**Economic and Social Council**Distr.: General  
6 August 2021

**Economic Commission for Europe****Inland Transport Committee****World Forum for Harmonization of Vehicle Regulations****Working Party on Lighting and Light-Signalling****Eighty-fifth session**

**UN Regulation No. 48 (Installation of lighting and light-signalling devices):****Proposals for amendments to the latest series of amendments****Proposal for Supplements to UN Regulation No. 149 and to the 06, 07 and 08 series of amendments to UN Regulation No. 48****Submitted by the expert from the International Automotive Lighting and Light Signalling Expert Group\***

*Add a new paragraph 2.8. in Annex 12; to read:*

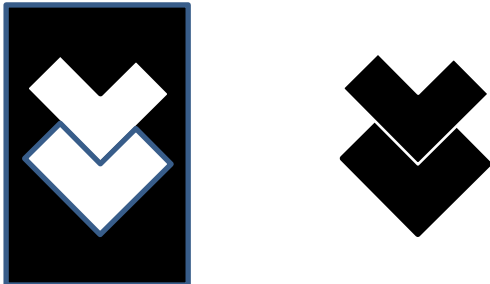
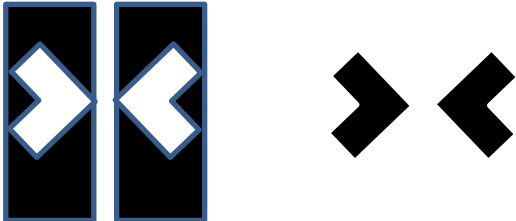
“**2.8. For the test sections A, B, C and E in the table above the engineers conducting the tests shall evaluate Driver Assistance Projection if installed.”**

4.11. In this paragraph a specification for testing the conformity of Driver Assistance Projection when the ADB tests are carried out has been included.
